**Planning Staff Report to
Greenville Planning Commission
January 14, 2022**
for the January 20, 2022 Public Hearing

Docket Number: FDP-10-2021
Applicant: NHE Inc./Taylor Davis
Property Owner: Laurens Road Church of God; Church of God TRS; Ovata Land Holdings LLC
Property Location: LAURENS ROAD AND ACKLEY ROAD
Tax Map Number: 019800-04-03200, 019800-04-00200, 019800-04-00300
Acreage: 3.87 Acres
Zoning: PD, Planned Development District

Proposal: FINAL DEVELOPMENT PLAN OF 3.87 ACRES
Staff Recommendation: Recommend Approval with Conditions and Comments

UTILITY
PLAN

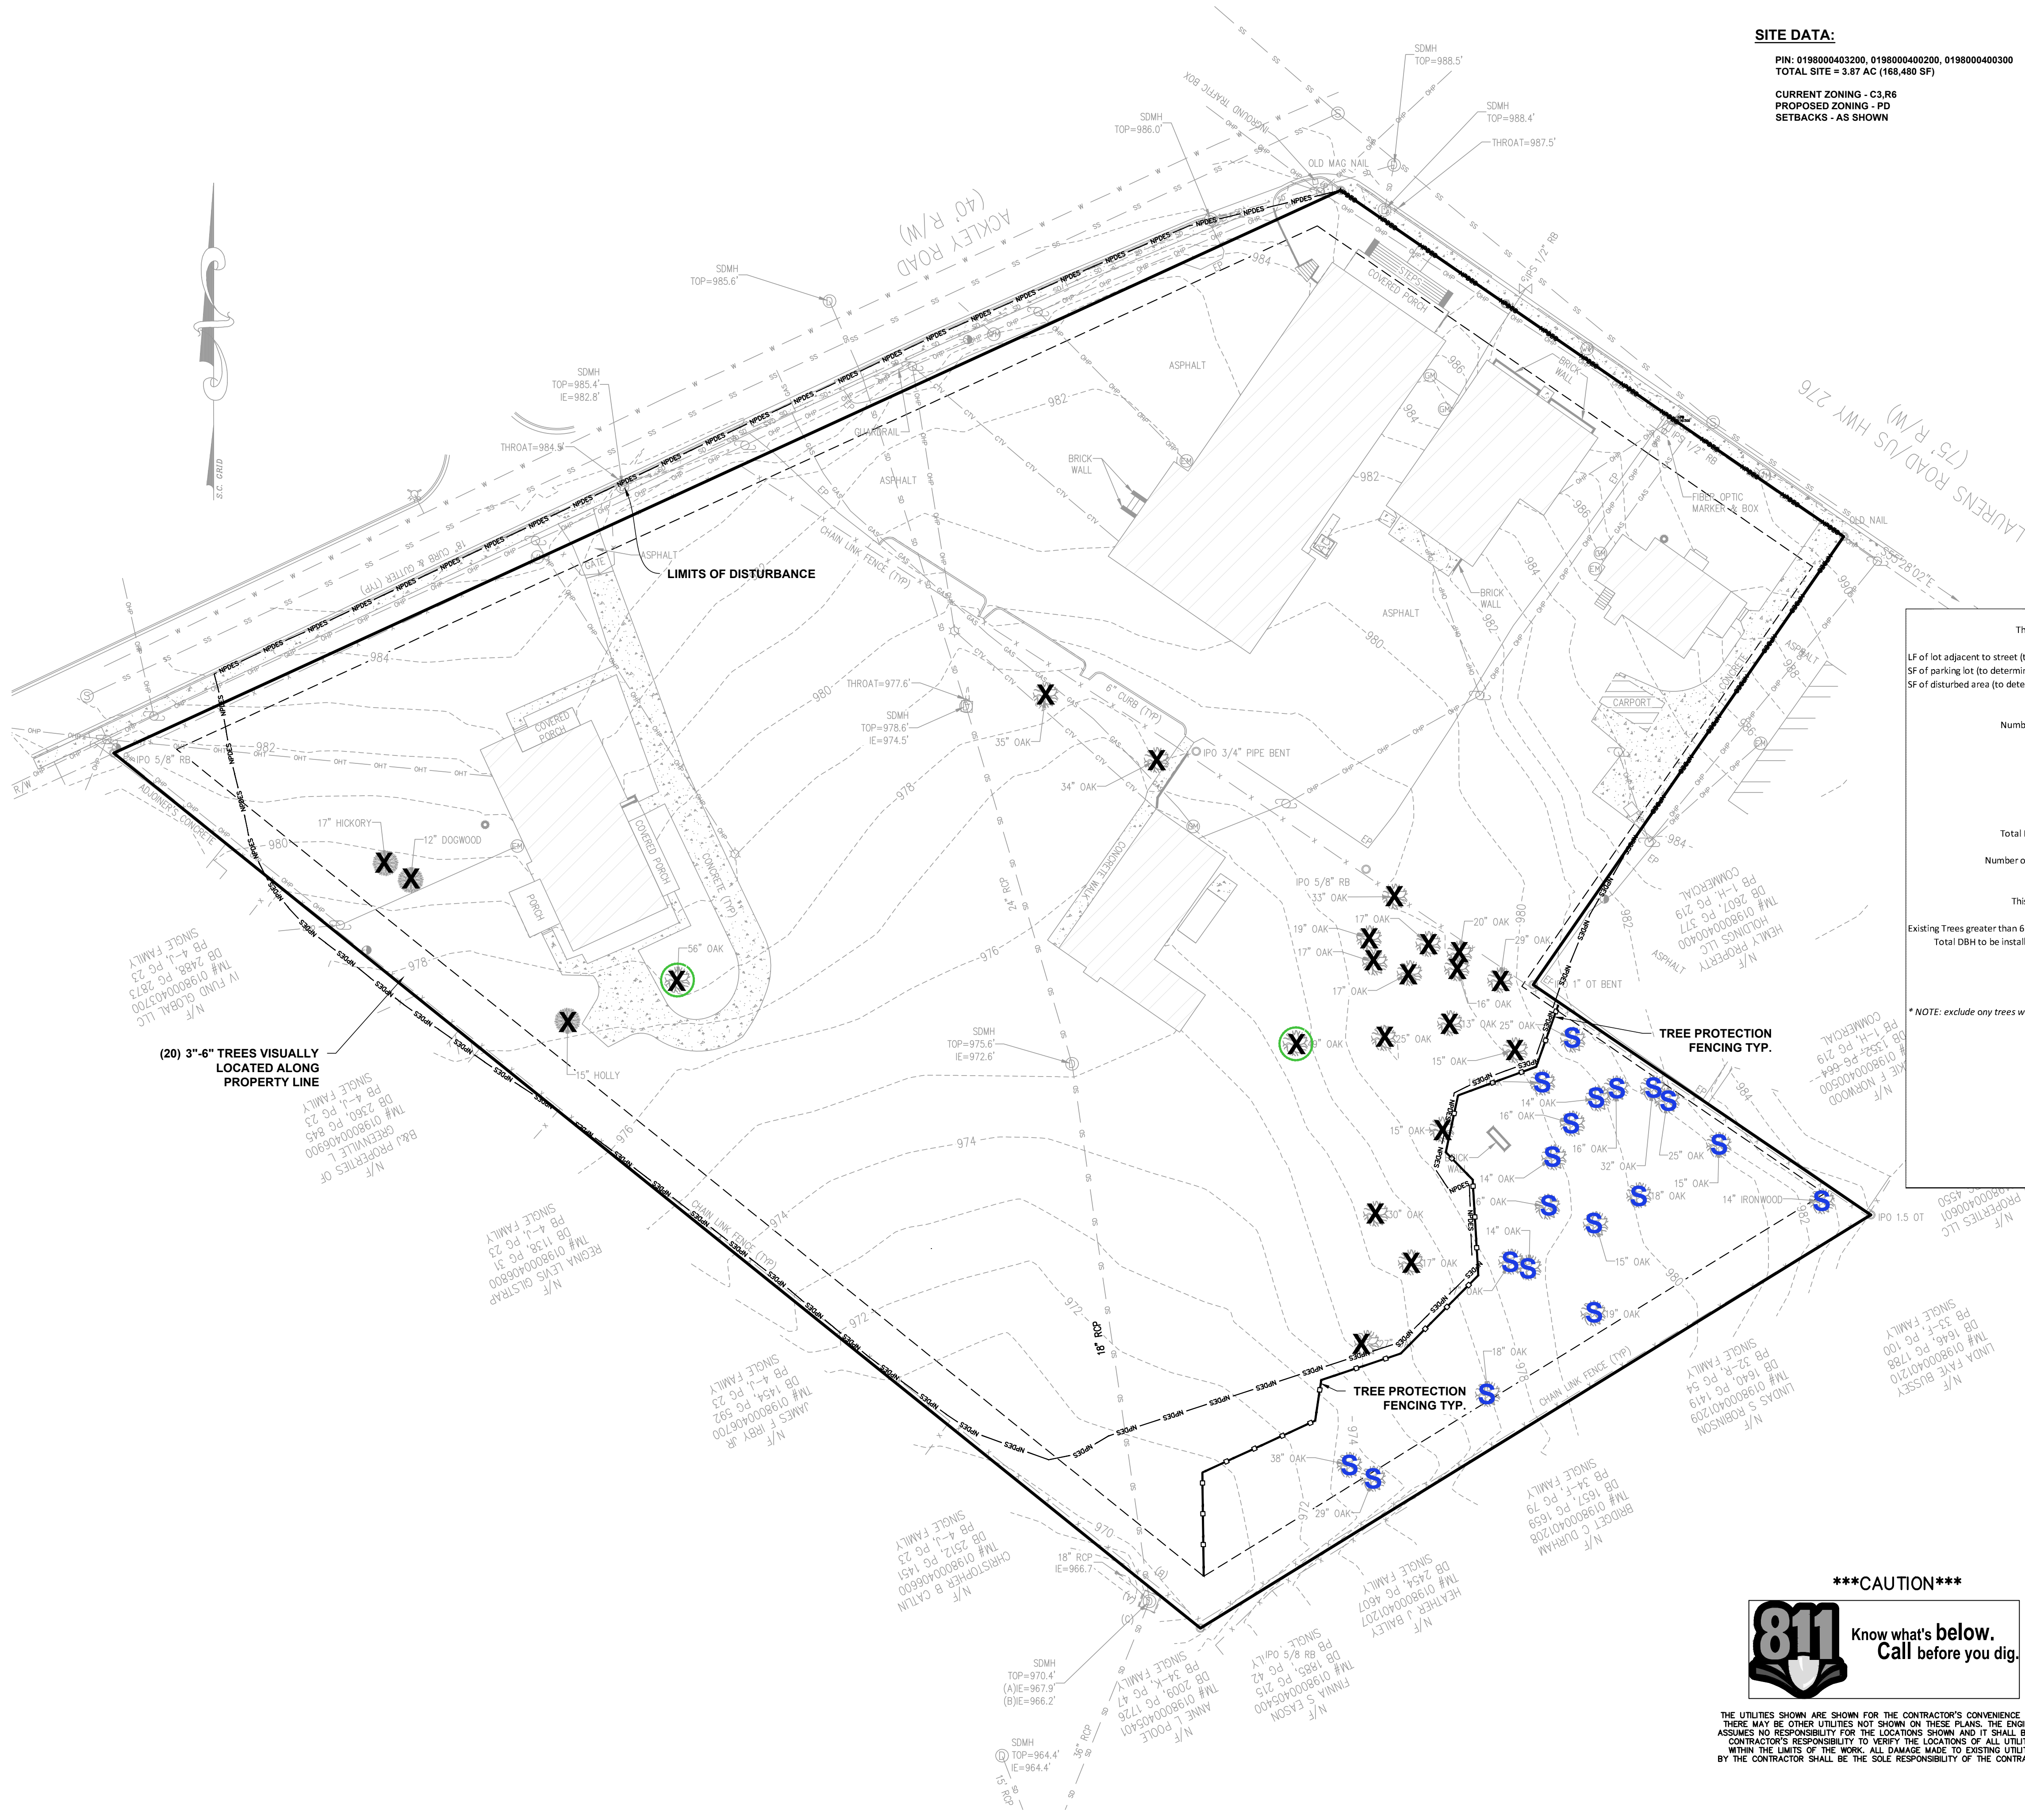
Loading zone space needs to be removed from Ackley Rd.

At time of site permit, they will have to show aerial fire access (26') drive aisles on property. The access from Laurens is too busy. When this continues for future development, we will give further comments if needed.

- 6) Loading zone space needs to be removed from Ackley Road.
- 7) The City is currently looking into installing a left turn lane with at least 100 feet of storage. All improvements will be placed in the existing right of way. However, this may impact the proposed location of the new sidewalk installed in front of the proposed apartments.

LANDSCAPE PLAN

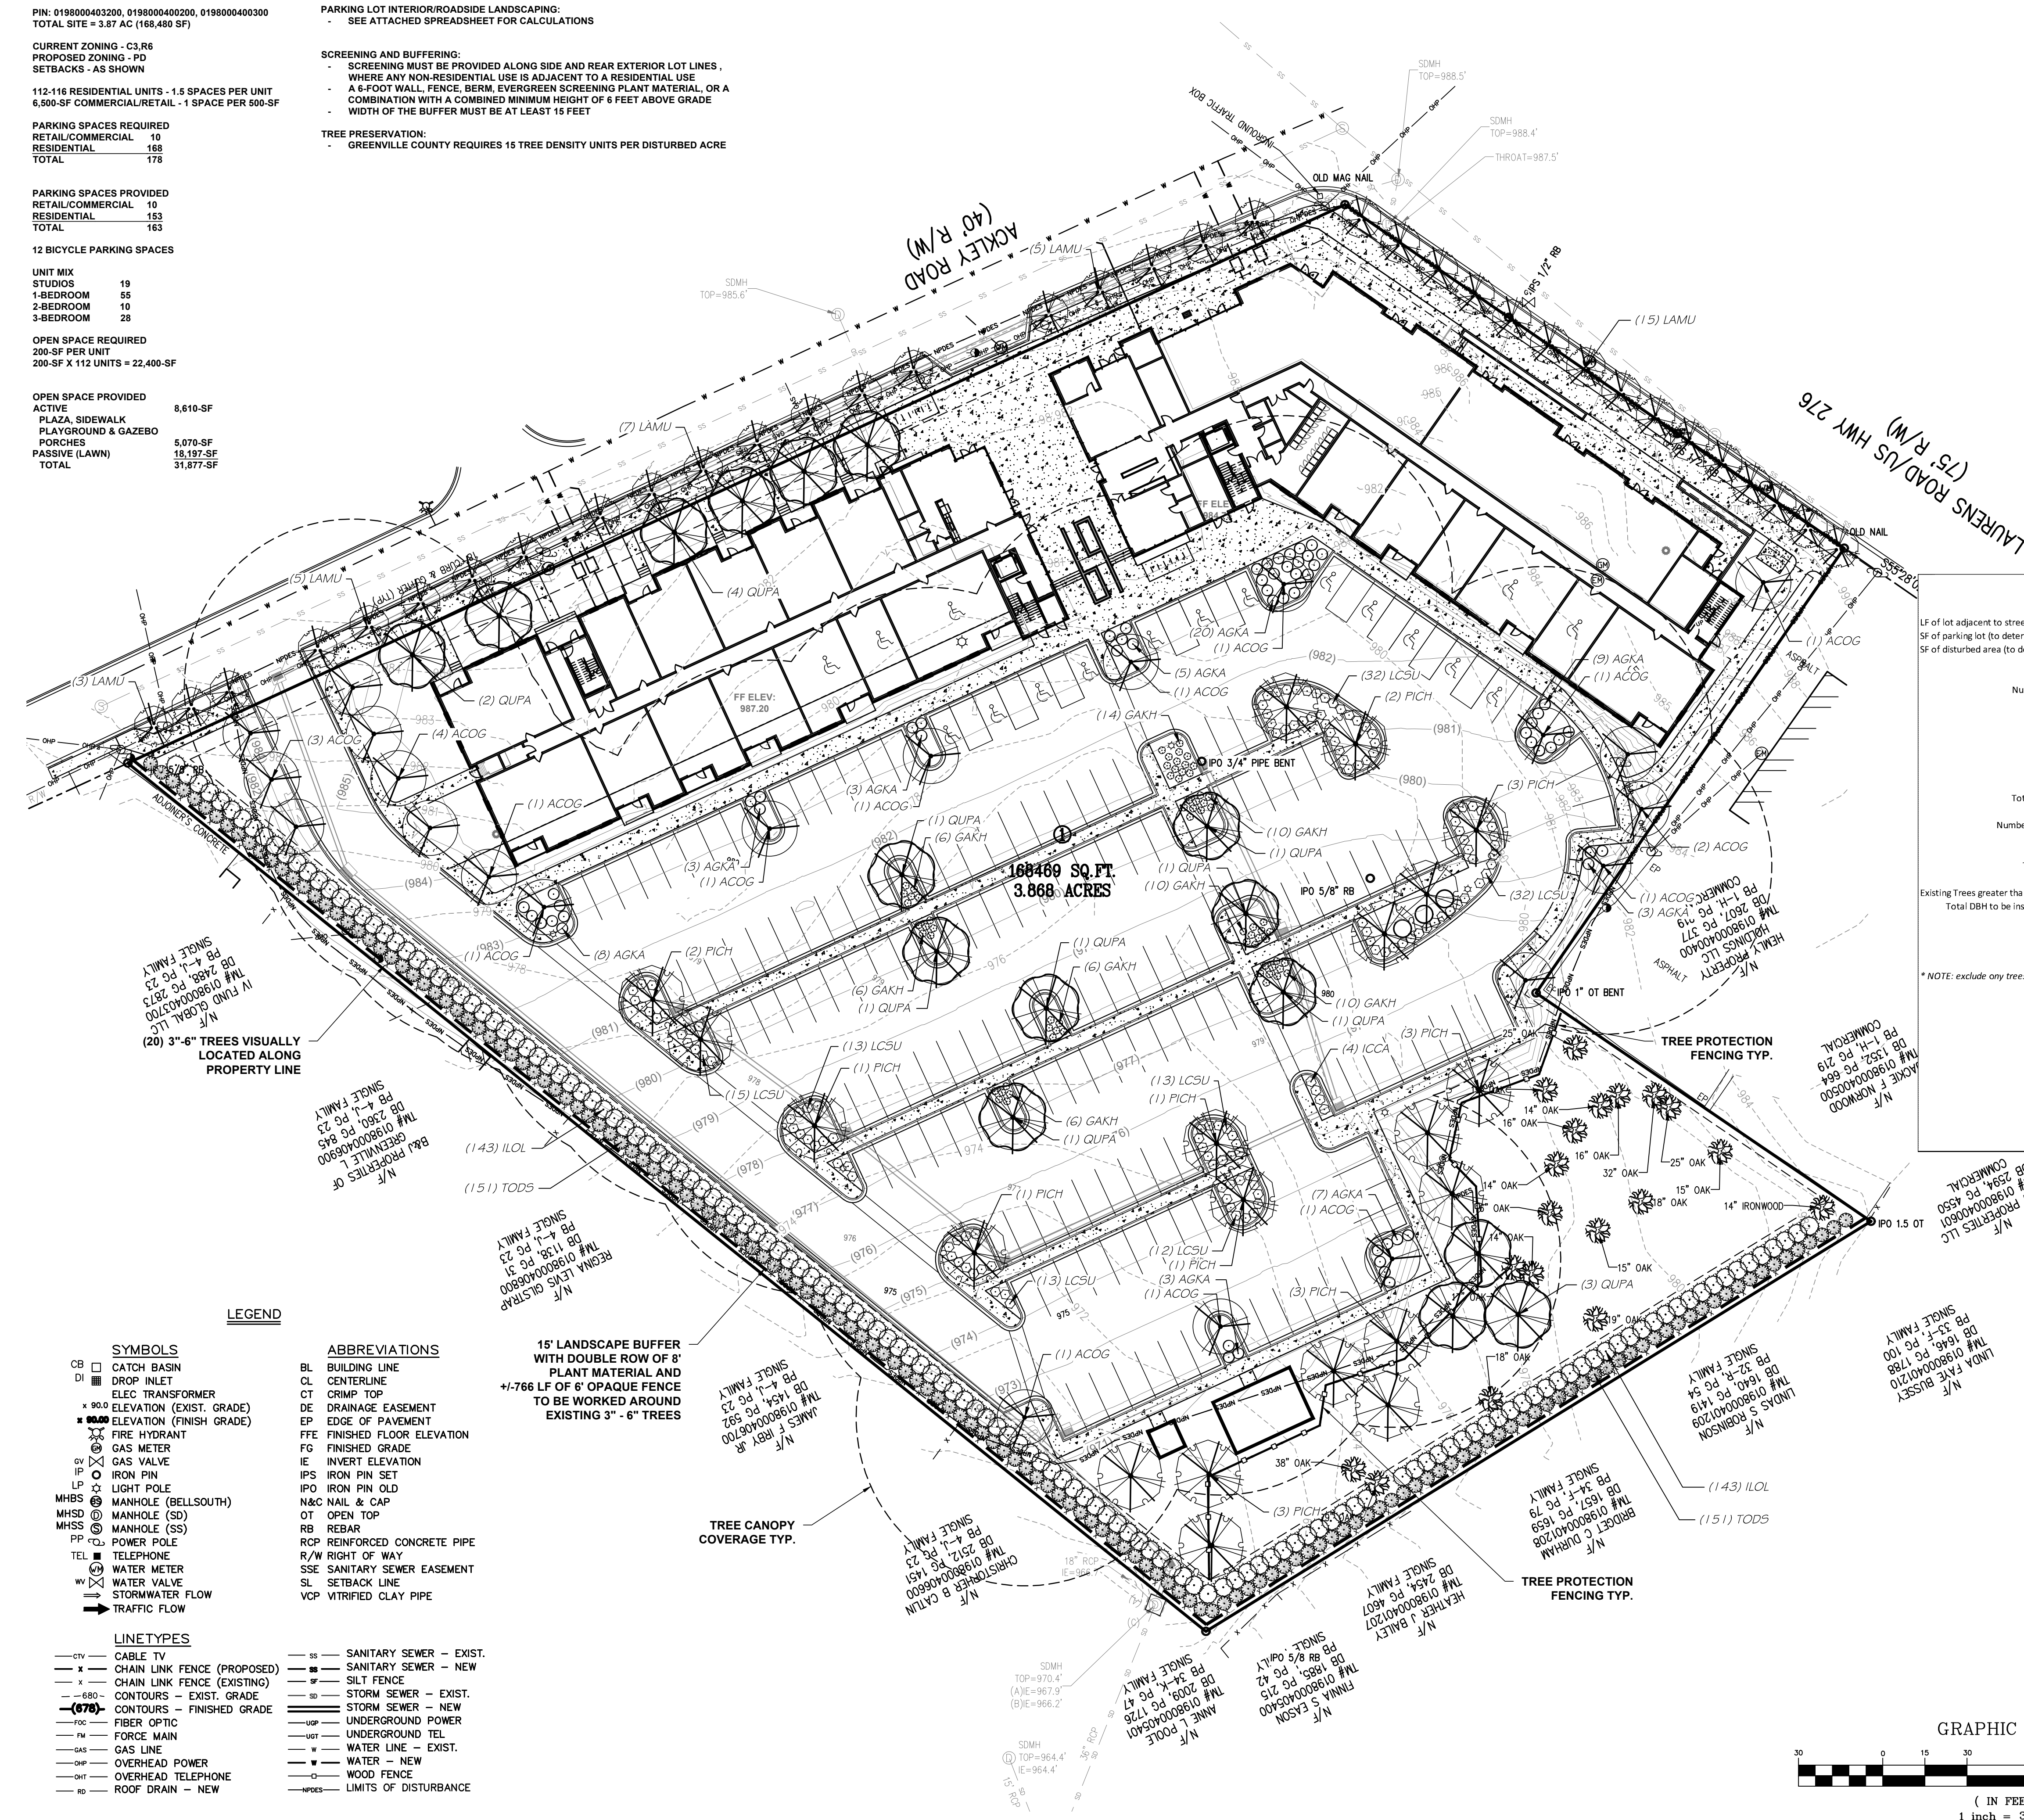
Applicant should be sure to mitigate any tree removals according to 19-6.3 Tree Protection. Parking lots should be sure to meet the interior parking lot landscaping requirements. Keep in mind no more than 10 parking spaces should be in line without a landscape island that contains a canopy tree. For every 2000 sf of parking area, one canopy tree and 8 shrubs are required. Parking lots should be screened from any adjacent use or public right of way. Street trees are required at 1 per 40 feet of street frontage for canopy trees or 1 per 20 feet for understory trees if overhead utilities are present. Foundation plantings according to non-single family residential are also required as per 19-6.5. Please also screen any ground level utilities such as sutera units, transformers, HVAC, etc, with both a fence at least the height of the utility and 48-inch evergreen shrubs around all sides except for sides used for accessibility. Site disturbance and building permit applications should include a detailed landscape and mitigation plan for review by landscape staff.

SCHEMATIC LANDSCAPE PLAN PROVIDED.
PERMIT LANDSCAPE PLAN WILL COMPLY WITH
THE CURRENT CITY LANDSCAPE ORDINANCE AND
THE PLANNED DEVELOPMENT STATEMENT OF
INTENT.
